Title ***DONGLE01***

Revision:1.4

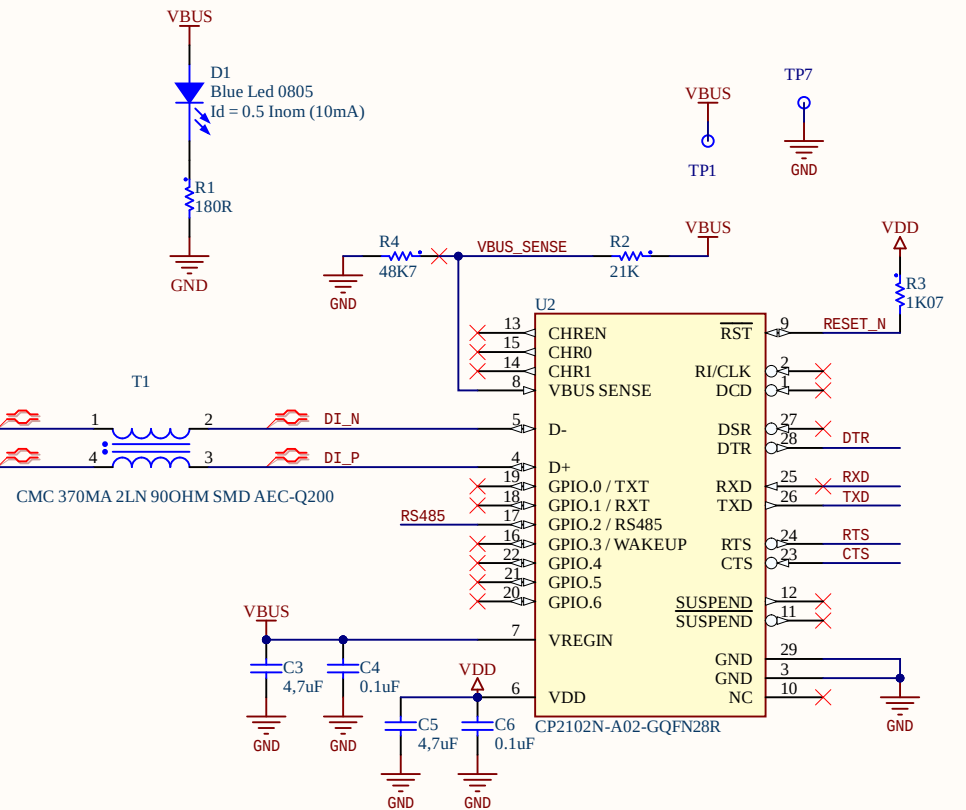
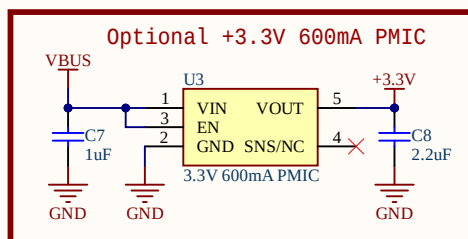
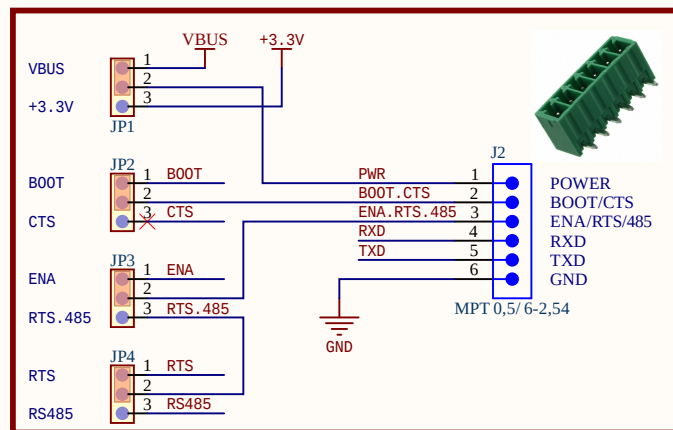
Rev.1.4: C1 and C2
corrected to 4,7uF.
Added new J1.

Nunca ajuste JP2 em BOOT quando usar a placa DONGLE02. SERIGRAFIA RXD E TXD INVERTIDA. TEM QUE REVISAR E CONSERTAR. FIXED AT V.1.2
